SI B63 14 10
Lights

March 2013
Technical Service

This Service Information bulletin supersedes SI B63 14 10 **dated November 2010.**

Rear Lamp Leaks

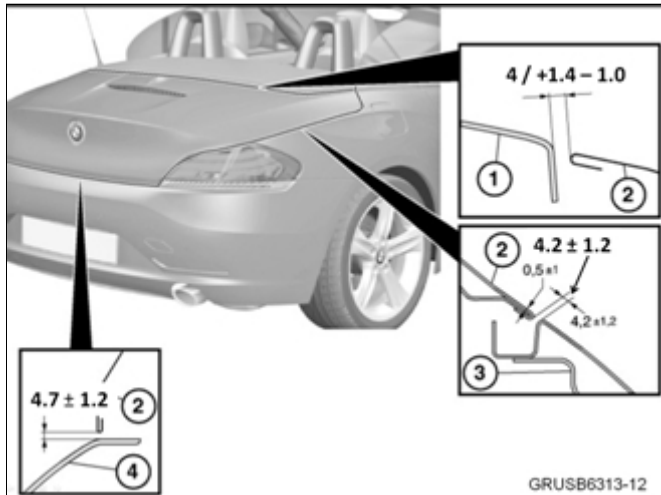
<ol style="list-style-type: none"> 3. After removing the taillight, mask the three holes with
--	--

“Protection Foil” with the part number shown below.

Note: Vehicles produced from October 14, 2011 to February 20, 2012 already have the protection foil.
